## Executive Director's Recommendation

Commission Meeting: April 4, 2013

<b>PROJECT</b> <b>Millennium Project</b> <i>Arlington National Cemetery</i> <i>Arlington County, VA</i>	<b>NCPC FILE NUMBER</b> <i>7457</i>
<b>SUBMITTED BY</b> <i>United States Department of Defense,</i> <i>Department of the Army</i>	<b>NCPC MAP FILE NUMBER</b> <i>1.61(38.00)43705</i>
<b>REVIEW AUTHORITY</b> <i>Federal Project in the Environs</i> <i>40 U.S.C. § 8722(b)(1)</i>	<b>APPLICANT'S REQUEST</b> <i>Approval of comments on concept design</i>
	<b>PROPOSED ACTION</b> <i>Approve comments as requested</i>
	<b>ACTION ITEM TYPE</b> <i>Staff Presentation</i>

Figure 14: Tree Stand Ages – with Millennium Project overlay

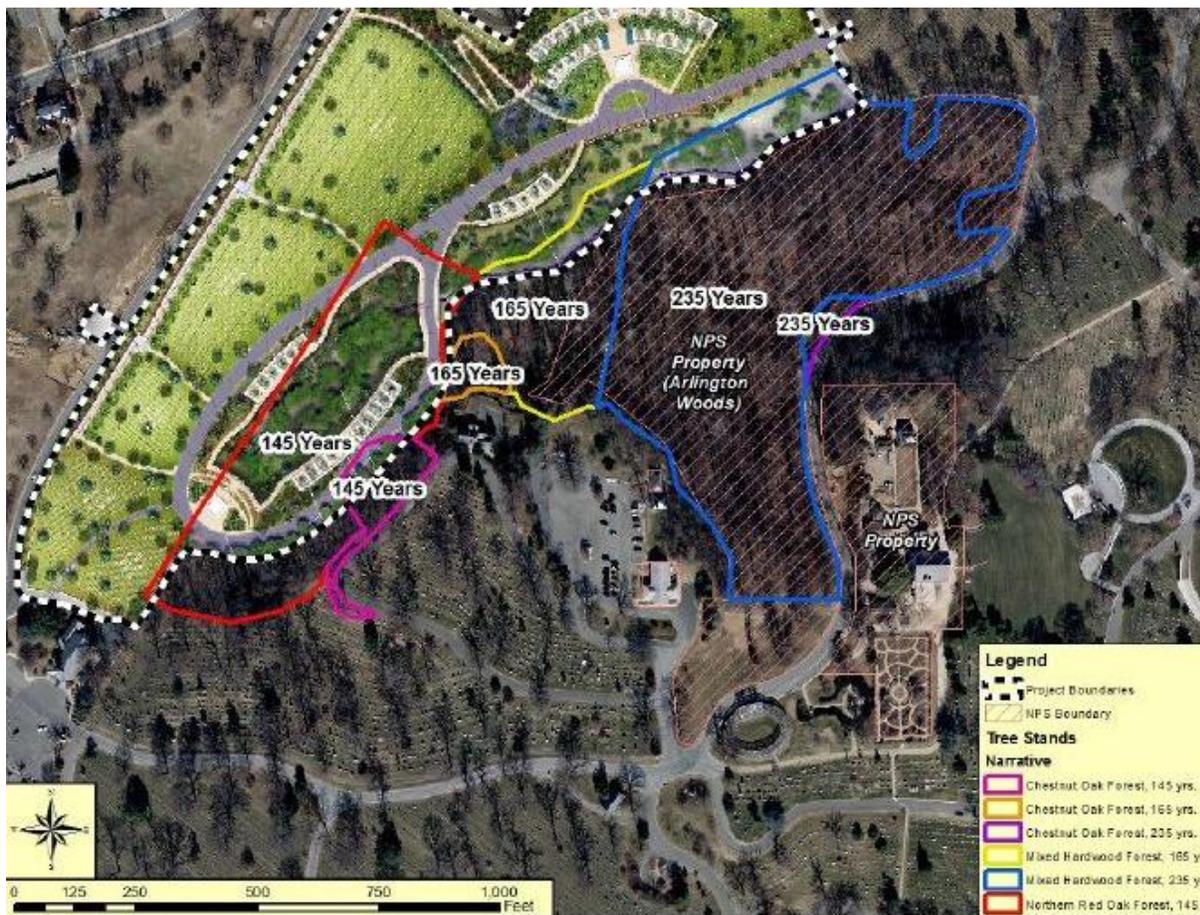
While this table indicates that the number of trees to be removed has diminished with each of the design alternatives, it does not describe anything else about the trees. Some of the trees proposed to be removed have an historic value as they are located in Section 29, which is part of Arlington House Woods. As was noted earlier, this forested area was part of the historic setting that was described in the National Register nomination for Arlington House. Arlington House Woods is a

24-acre parcel that is located west of the former Robert E. Lee Mansion in Arlington National Cemetery and contains several tree stands that the Army states range from 145 years old to 235 years old. The Army notes that the 165-year-old trees will remain untouched. NPS manages the stand of trees that are 235 years old and this portion of Arlington House Woods is not included in the project area and will not be affected.

Alternative E1 will impact the 145 year old tree stand. The Army states that it will impact 2.63 acres of the 5.84 acre area where the 145 year old trees are located. The 165-year-old tree stand is approximately 2.74 acres, is included in the project area, but will not be built upon.

Arlington County and the National Trust for Historic Preservation, on the other hand have provided comments to the Army stating that this project will adversely impact the historic stand of trees that are part of Arlington House setting and have requested that the Army redesign the project so this part of the site is not impacted at all. They also noted: the removal of a large portion of the historic boundary wall, changing the historic setting of the Arlington House through the removal of historic trees, and archeological resources. The Army states that the impact to this part of the Arlington Woods is unavoidable if this area is to be used for burials and circulation and will try to minimize this impact through careful study of the site.
